2016/SDD-23(EK)

Subject: Application for an Interim Planned Development-Transit (IPD-T)
and Special District Permit Application No. 2016/SDD-23
Project: Manaolana Place Hotel and Residential
Condominium Development Project
Landowners: Manaolana Partners, LLC
Kaijima Kagaku USA Inc.
Applicant: Manaolana Partners, LLC
Agent: Kusao & Kurahashi, Inc. (Keith Kurahashi)
Location: 1685, 1687, 1689, 1691, and 1695 Kapiolani Boulevard,
508 and 512 Atkinson Drive
1674 and 1676 Kona Street – Kalia, Waikiki
Tax Map Keys: 2-3-41: 1 and 2
Acceptance Date: April 5, 2016

FINDINGS OF FACT, CONCLUSIONS OF LAW
AND RECOMMENDATION

EXHIBIT B-1

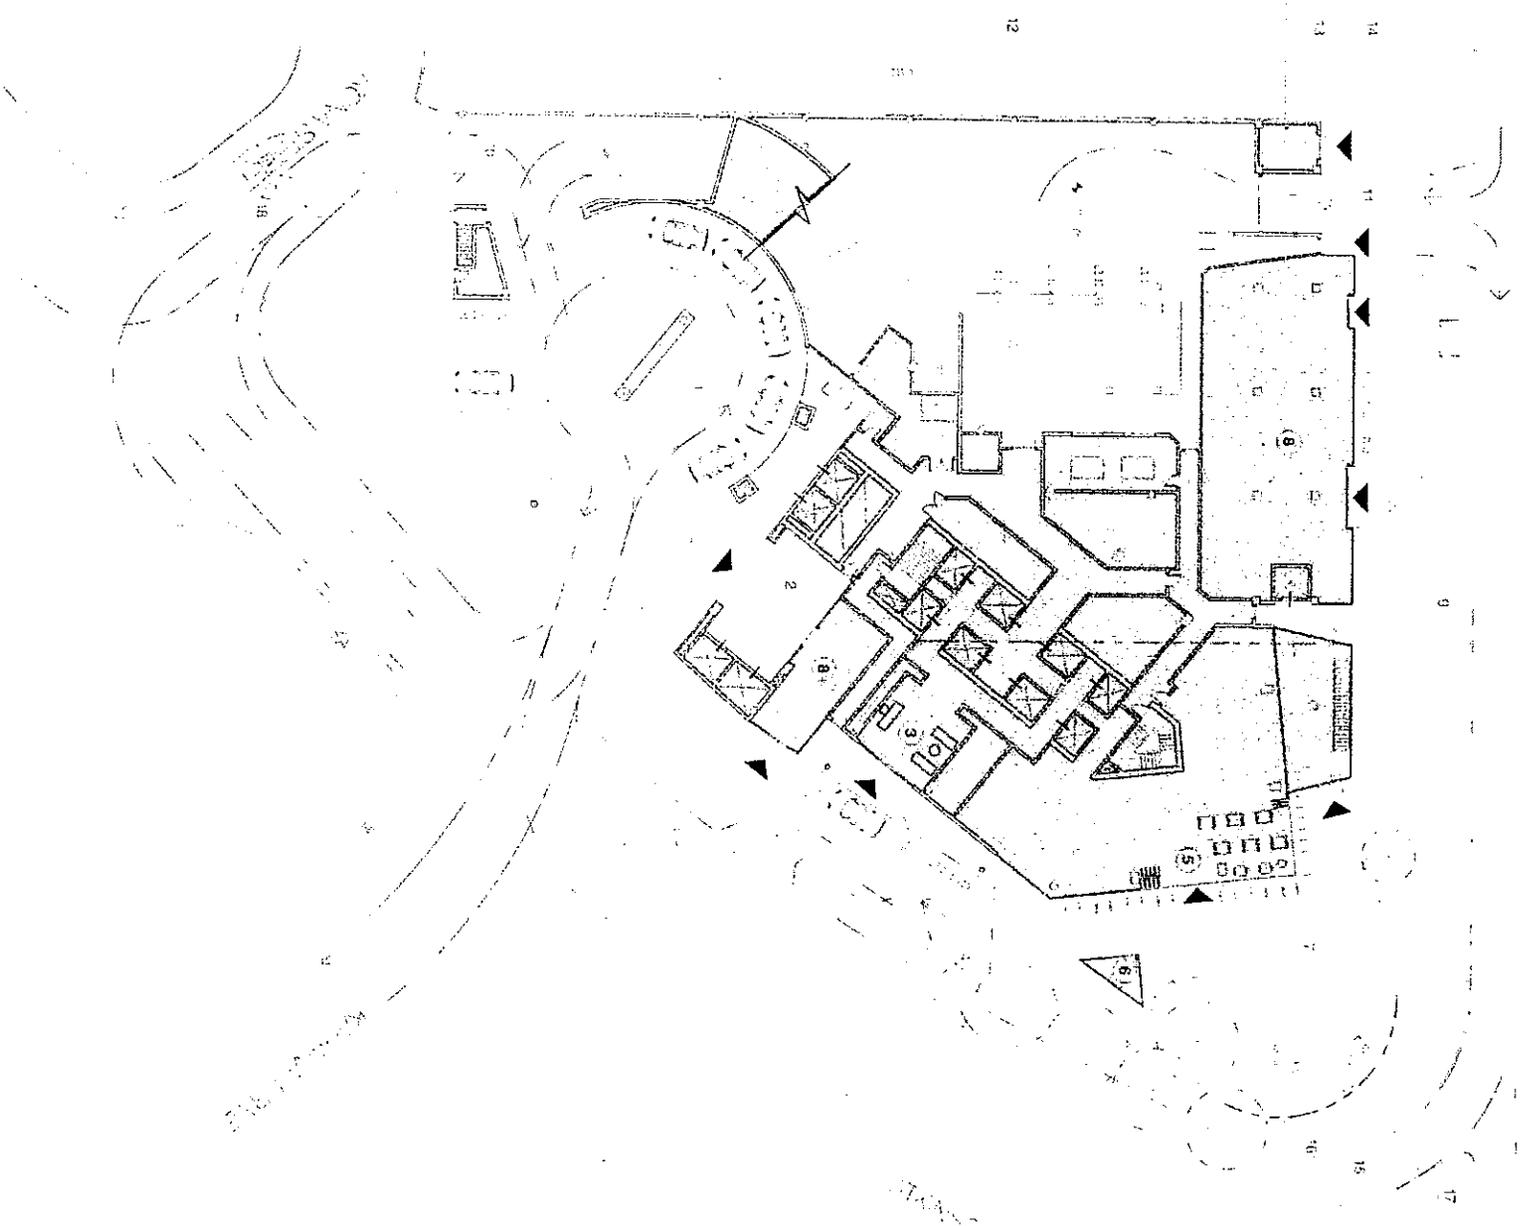
- b. Residential Drop-off Area: The DTS commented that there are traffic and pedestrian safety concerns with the inclusion of an on-site drop-off area for the residential condominium users of Atkinson Drive, which is a relatively high pedestrian traffic area. The DPP TOD Division also commented that the current driveways and landscaping are inconsistent with TOD principles to prioritize walkability and the sidewalk continuity in front of the residential lobby must be maintained. With the current plan, pedestrians are redirected towards the building, rather than giving them a choice to continue directly without diversion. The plan also introduces automobile traffic into the pedestrian realm.

According to the Applicant, this drop-off area will be designed to feed into the residential lobby and elevators, and will be used mostly for taxi pick-up and is not anticipated to be highly used. However, with this plan, vehicular circulation will be prioritized over pedestrian mobility. There will be a disruption in pedestrian flow and conflict between vehicles and residents in the drop-off area. Removing the driveway will alleviate pedestrian-resident conflicts and ease pedestrian flow with a linear, continuous path along the street. Therefore, the DPP finds that the drop-off area should be removed, particularly since it will not be highly used. A resident drop-off area could be designated in the parking garage or in the hotel drop-off area to accomplish the goal. Therefore, as a condition of approval, the Applicant will be required to remove the residential lobby drop-off area along Atkinson Drive.

- F. The Applicant shall provide a minimum of 276 parking spaces on the site.
- G. The pull-out driveway and residential drop-off area on Atkinson Drive shall be removed from the plans and replaced with a public gathering space.

- 4. Submit a revised site plan showing a public gathering space along Atkinson Drive (replacing the pull-out driveway and residential drop-off area).

EXHIBIT B-16

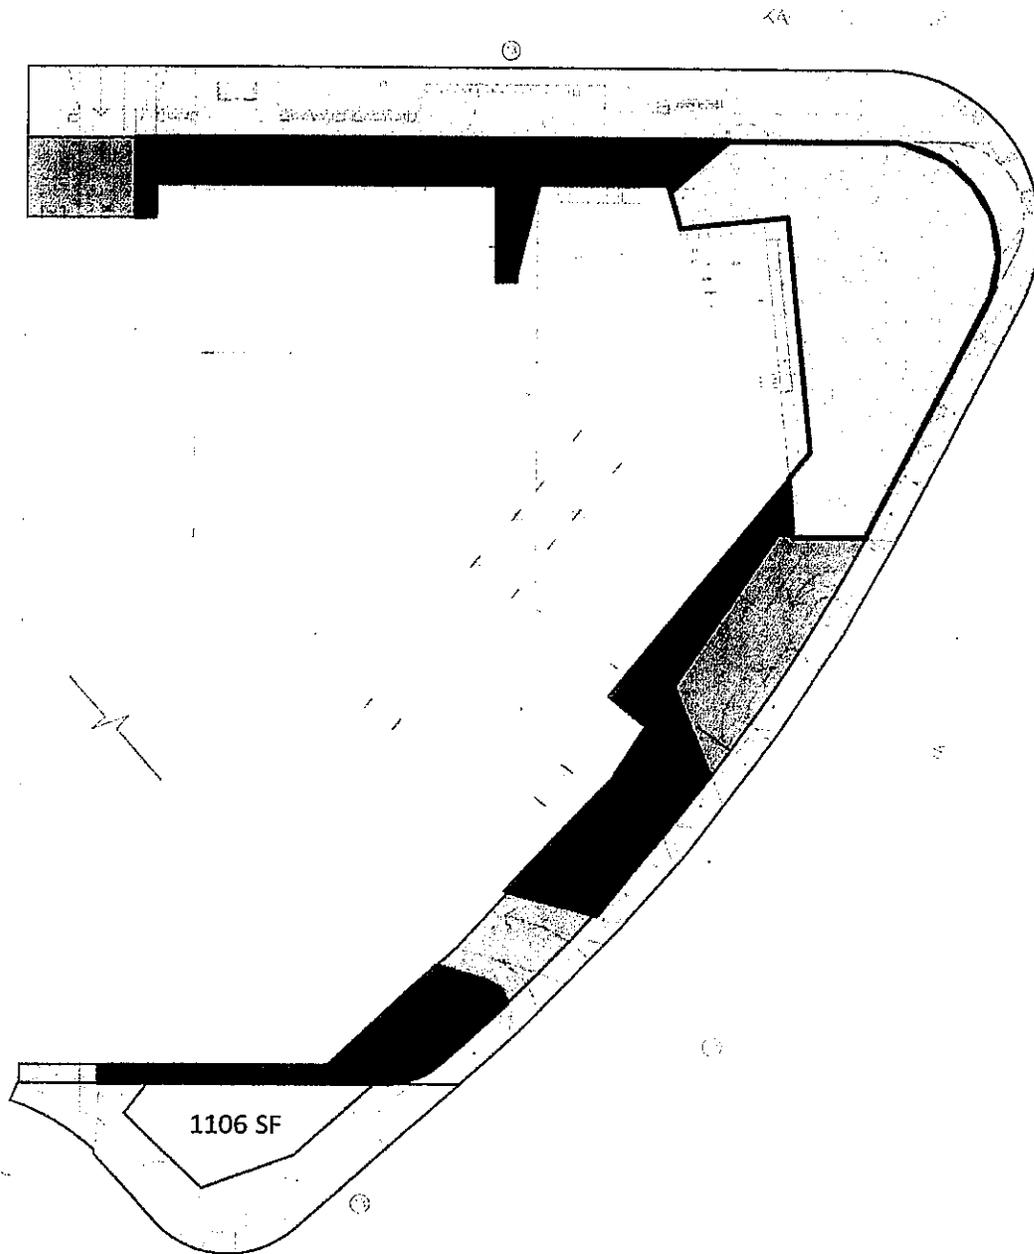
- A 4,856-square-foot publically-accessible plaza at the corner of Kapiolani Boulevard and Atkinson Drive (Exhibits B-2, B-16, and D-7). The public plaza will have a café kiosk and outdoor seating, benches, shade trees, planter boxes and other landscaping, a restaurant with outdoor seating, and a fountain as the focal point.

4. Open Space and Landscaping: Open space should be designed with a preference for publically-accessible, highly-usable parks and gathering spaces rather than buffering or unusable landscaped areas. The proposed public plaza at the corner of Kapiolani Boulevard and Atkinson Drive meets this criteria and provides places not only for walking or outdoor retail activity, but spaces to sit and enjoy the surrounding area with benches, landscaping, a water feature, decorative paving, and “vertical gardens” (wall surfaces above the second story that will be covered in plants and living greenery, as shown on Exhibits D-4, D-6, and D-7).

- H. All construction plans and drawings shall be reviewed by the DPP Civil Engineering Branch for compliance with drainage and grading requirements.
- I. The public plaza proposed at the intersection of Kapiolani Boulevard and Atkinson Drive shall be available to the public and shall be maintained by the Applicant.
